**RE: Planning Proposal 150 Lismore Road, Bangalow (PP-2021-3615)**

Attachment 1. Detailed BCD Comments – Planning Proposal to rezone Lot 4 DP 635505, 150 Lismore Road, Bangalow

**RE: Lot 150 – Bangalow Industrial Estate – Further Advice Re Flood Modelling**

**RE: Updated Planning Proposal, 150 Lismore Road, Bangalow (PP-2021-3615)**

Figure 5.4 – Proposed Area to be Rezoned RU1 Primary Production and E3 Environmental Management

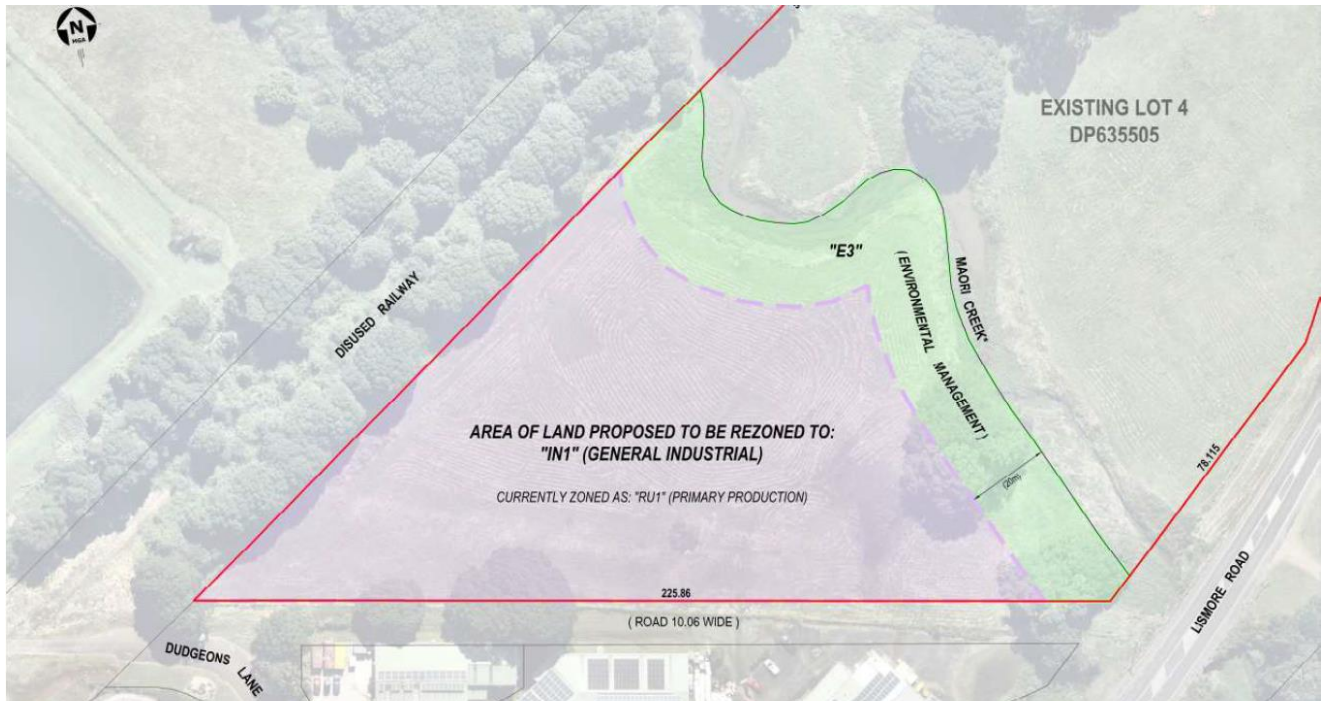
The planning proposal involves rezoning part of Lot 4 from RU1 Primary Production to IN1 General Industrial and rezoning of a 20 metre wide riparian corridor along Maori Creek to C3 Environmental Management as shown in Figure 5.4 in the planning proposal report (see below).

1. Given its EEC status, the 'soak' wetland portion of the site comprises HEV. As a result, the wetland, including a 20m buffer measured outward from the high bank surrounding the wetland, should be zoned C2 – Environmental Protection.

2. As Maori Creek is mapped on the BV Map (see Figure 1 overleaf), which is a component of HEV, land on both sides of Maori Creek should be zoned to C3 – Environmental Management, for a distance of 20m. This would align with the riparian corridor included on the BV Map, and result in a total riparian corridor width of 40m.

- Increase the C3-Environmental Management zone to 40 metres on the western side of Maori Creek.
- Apply a C3- Environmental Management zone to the freshwater wetland EEC (the 'soak' area).
- Apply a 20m C3-Environmental Management buffer to the eastern side of Maori Creek.

Figure 1.1 Rainfall and Stream Gauges

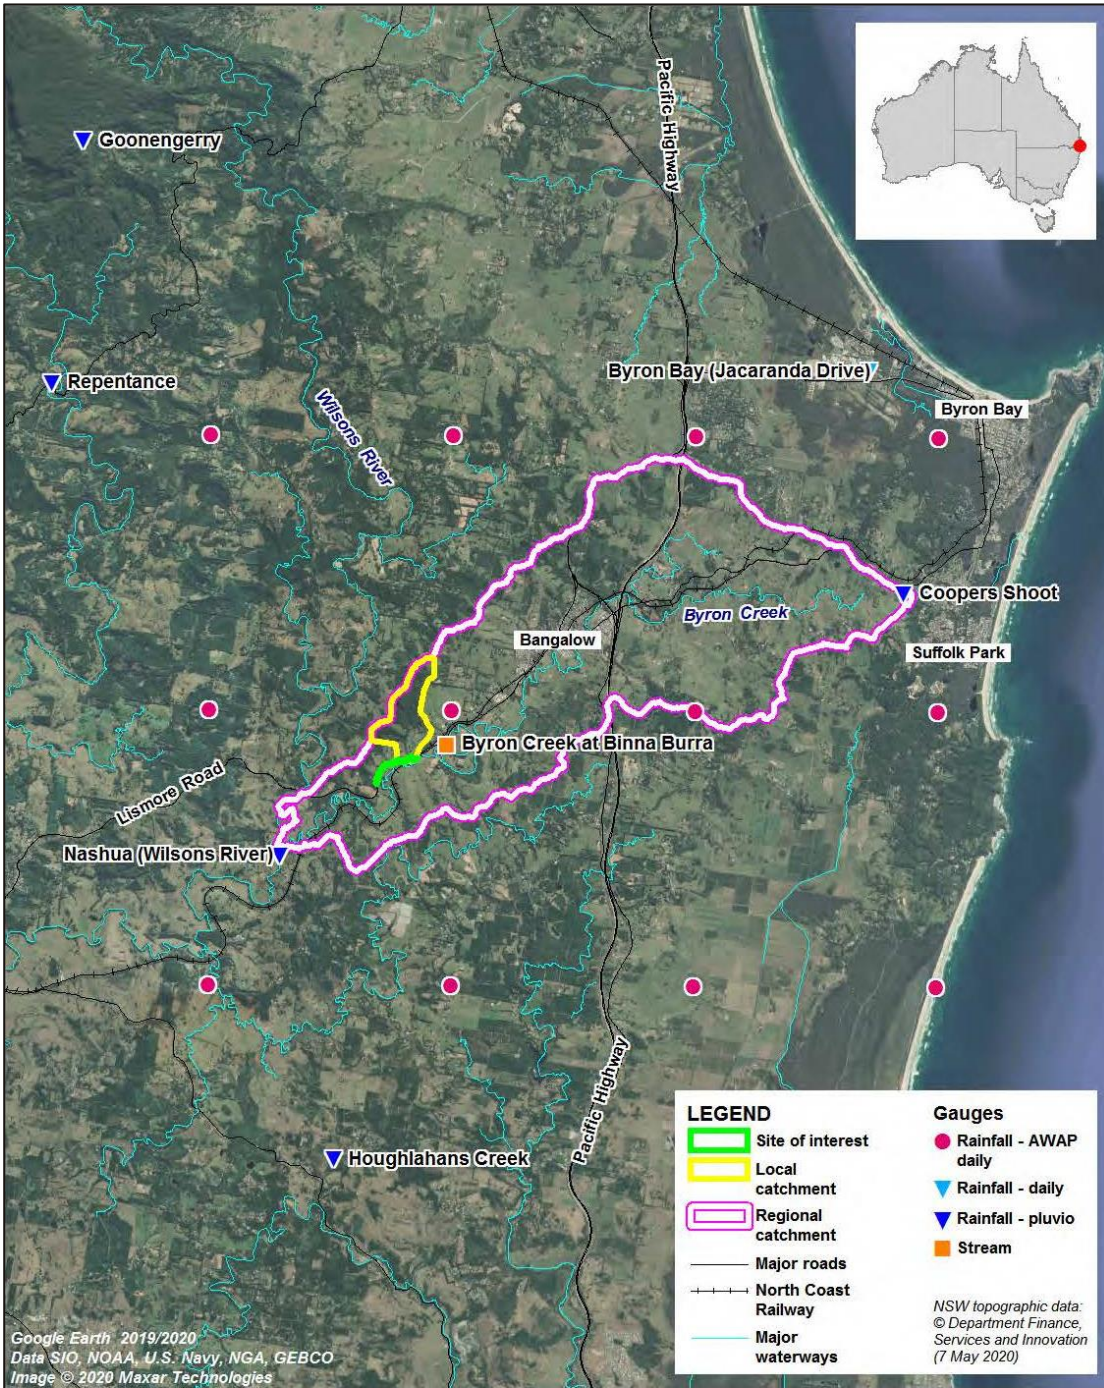
The BCD has reviewed the Flood Impact Assessment report prepared by BMT dated May 2021. The report indicates that the model had been calibrated to the March 2017 and February 2020 flood events in Byron Creek but no details regarding the calibration can be found in the report to support the reliability or performance of the models. For this reason, it is difficult to accept the findings of the design floods such as the 1%AEP and 5% AEP events.

The calibrations used historical recorded rainfall data from the surrounding areas to inform the hydrologic models (Figure 1.1, Figure 1.2). Real stream water level gauging data was used from a recording location in Byron Creek (at Binna Burra). The model terminates a few kilometres downstream of this gauge where it meets the Wilsons River inflow.
